PCN# 20250922000.1
Qualification of TIEM as an additional Assembly site
for select devices
Change Notification / Sample Request

Date: September 22, 2025

PCN Number:	20250922000.1	PCN Date:	September 22, 2025
Title:	Qualification of TIEM as an additional Assembly site for select devices		
Customer Contact:	Change Management team	Dept:	Quality Services
Proposed 1st Ship Date:	December 21, 2025	Sample requests accepted until:	November 21, 2025*

Marking differences sample:

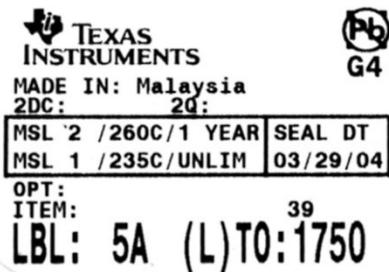
Texas Instruments is pleased to announce the qualification of TIEM as an additional Assembly site for select devices. Assembly differences are as follows:

Current A/T site		Additional A/T site
	TITL	TIM	TIEM
Wire diam/type	0.96mil Au	0.96mil Au, 1.0mil Cu	0.8mil Cu
Mold Compound	4209640	4211880	4211880
Marking differences	TI logo, pin 1 stripe, with G4	TI letter, pin 1 dot/dimple, without G4	TI letter, pin 1 dot, without G4
